Attachment 1

Technical Specification Changed Pages
in Support of the Pressure/Temperature Limits Report.

WNP-2

PRESSURE/TEMPERATURE LIMITS REPORT

Figure 1

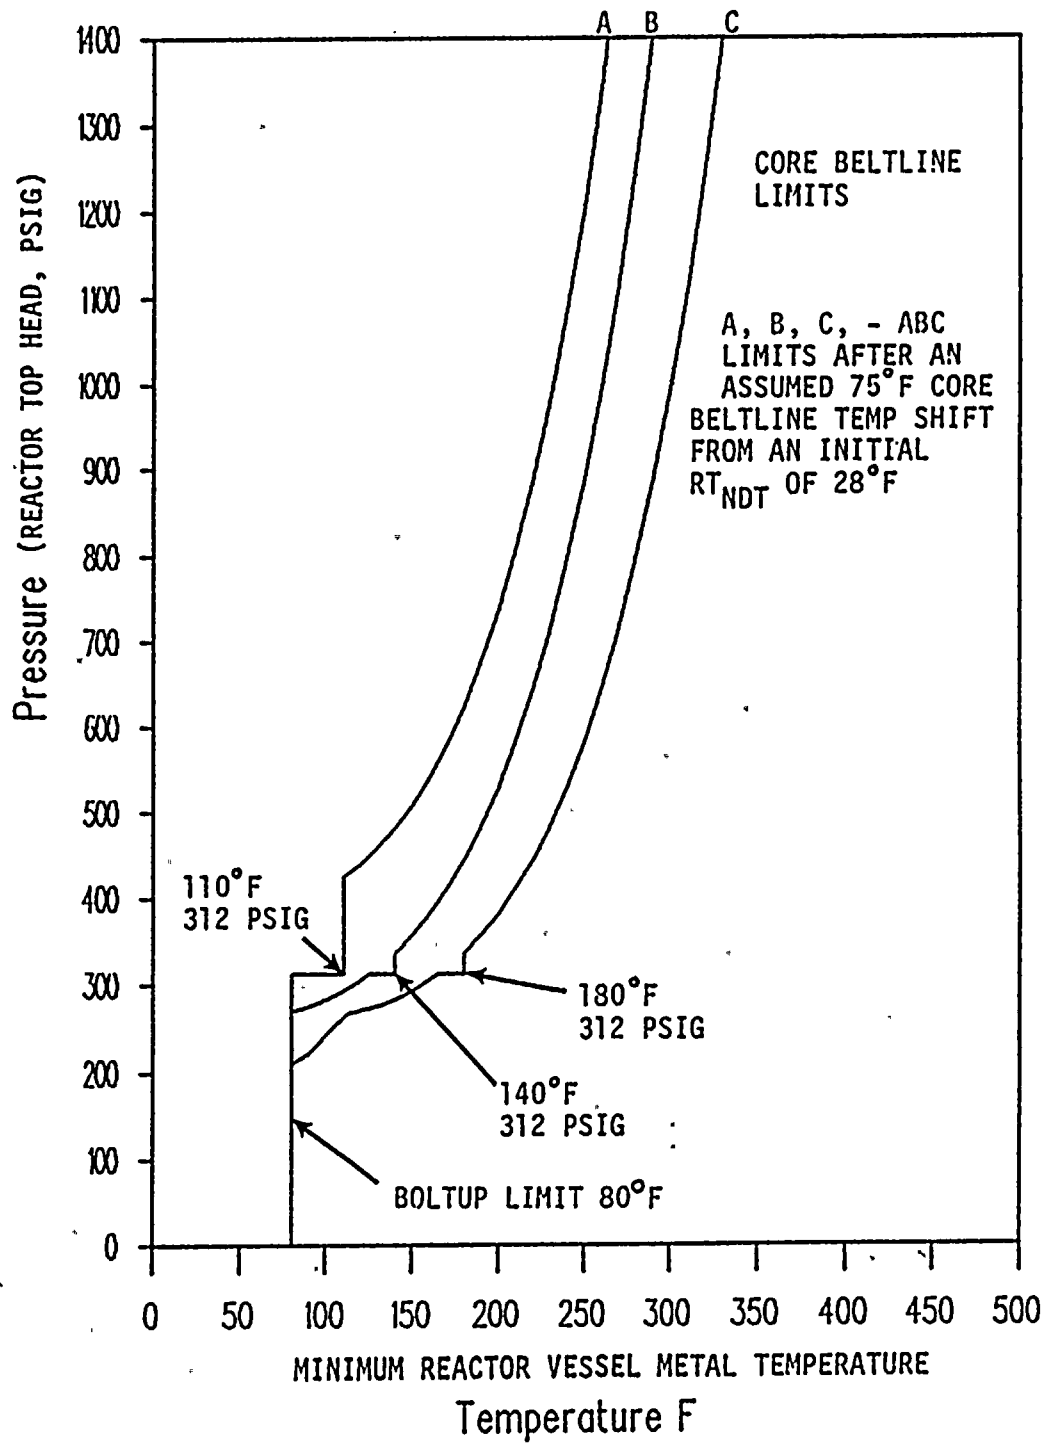
- 1) Allowable plant heatup and cooldown rates.
- 2) Curve A for hydrostatic or leak testing.
- 3) Curve B for heatup by non-nuclear means, cooldown following a nuclear shutdown and low power PHYSICS TESTS.
- 4) Curve C for operation with a critical core other than low power PHYSICS TESTS.

During system heatup, cooldown, and inservice leak and hydrostatic testing operations, the reactor coolant system temperature and pressure shall be determined to be within the below required heatup and cooldown limits: The pressure and temperature shall be determined at least once every 30 minute interval. The determined temperature and pressure shall be to the right of the appropriate curves in Figure 1.
